PROPOSED CHANGE  
TECHNICAL SPECIFICATIONS  
SALEM GENERATING STATION  
UNIT NO. 1

DESCRIPTION OF CHANGE

Figure 3.4=2 Salem Unit No. 1 Reactor Coolant System Heatup Limitations Applicable for the First 10 EPFY.

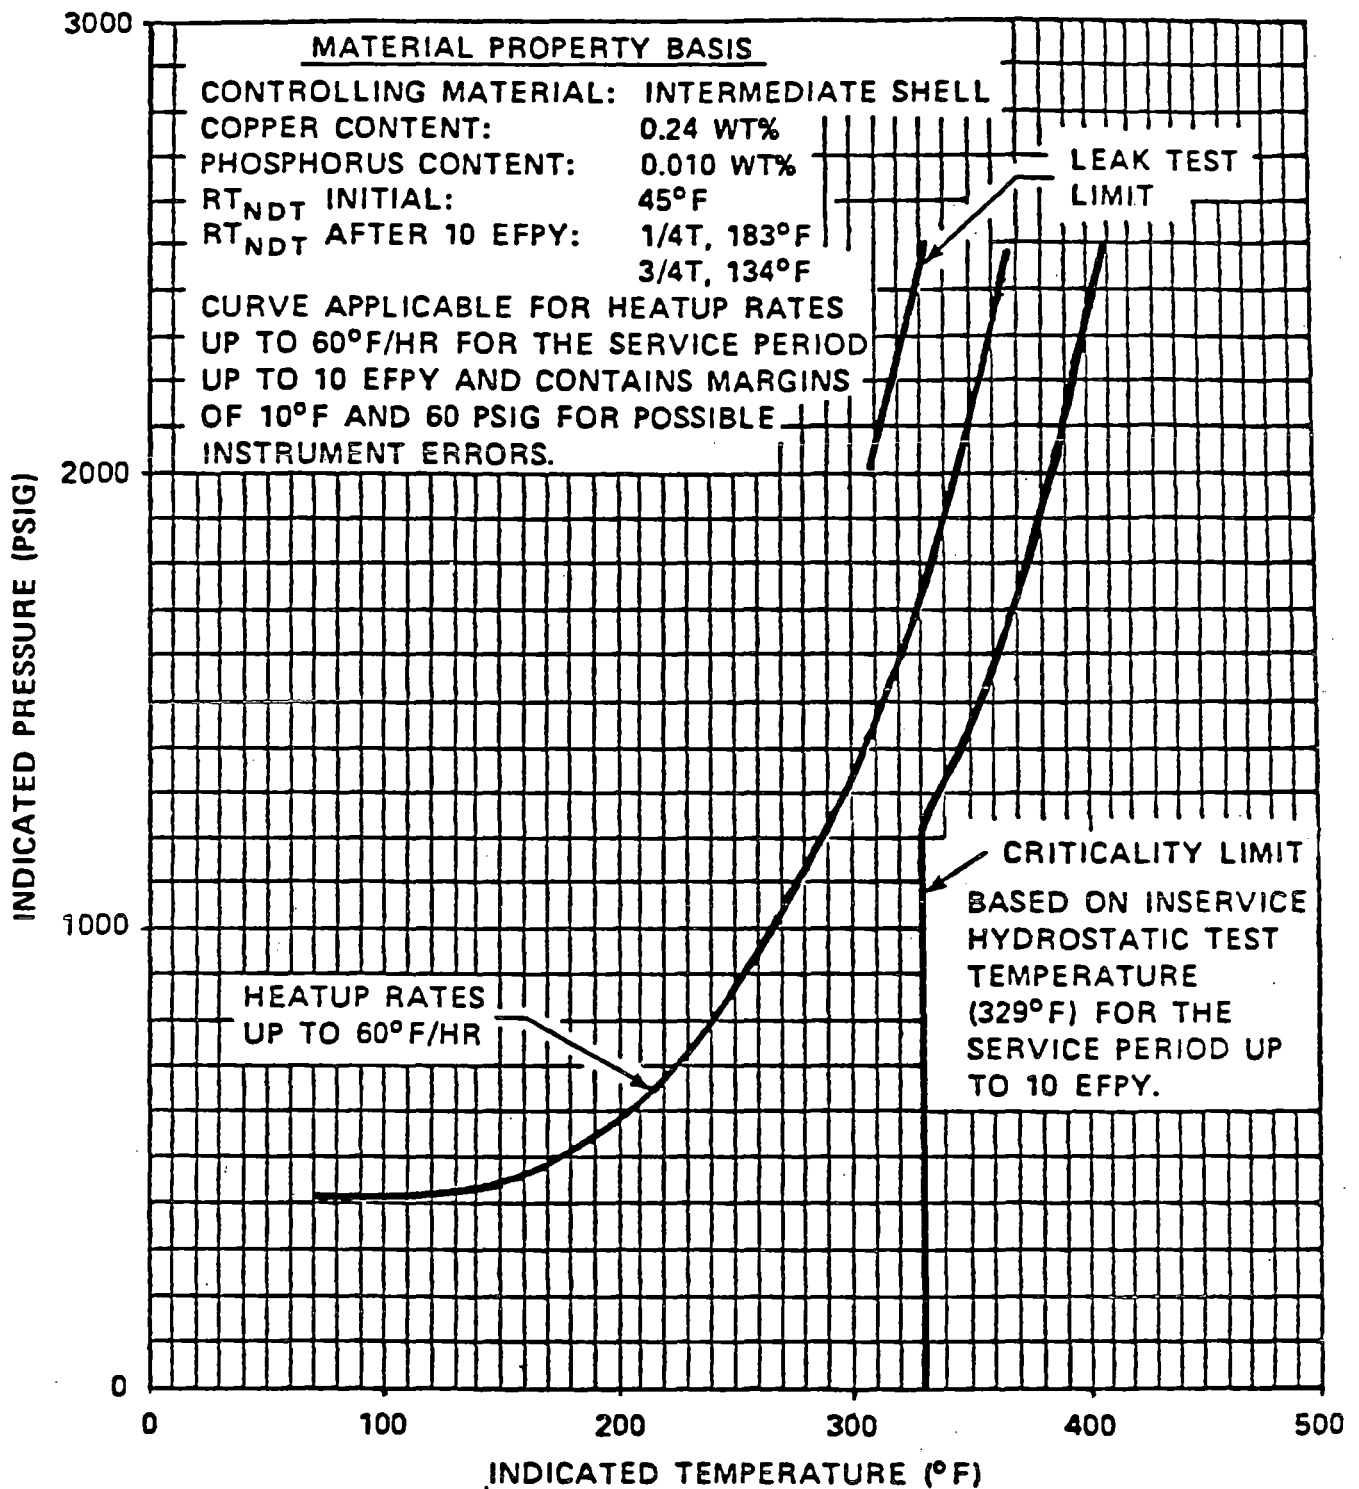
Technical Specifications Heatup and Cooldown Curves, Figures 3.4.2 and 3.4.3 shall be replaced with the attached revised figures.

The figures attached to this LCR are the revised heatup and cooldown curves developed from the Capsule T analysis performed by Westinghouse. Derivation of these curves was based on Appendix G, ASME III, 1977 and Summer 1978 Addenda. The analysis results were transmitted in WCAP 9678.

The results of the surveillance capsule analysis indicate that the reactor vessel has adequate toughness for continued safe operation. Adherence to the revised heatup and cooldown curves would ensure the prevention of nonductile failure. This change will be in accordance with the requirements of Tech. Spec. Surveillance Requirement 4.4.9.1.2 for Unit No. 1 and would not involve any Significant Hazards Consideration.

Since the new curves will result in more conservative operation of the reactor vessel, there is no increase in the probability or consequences of any accidents nor are any new accidents introduced. Margins of safety are increased by the more conservative operation.
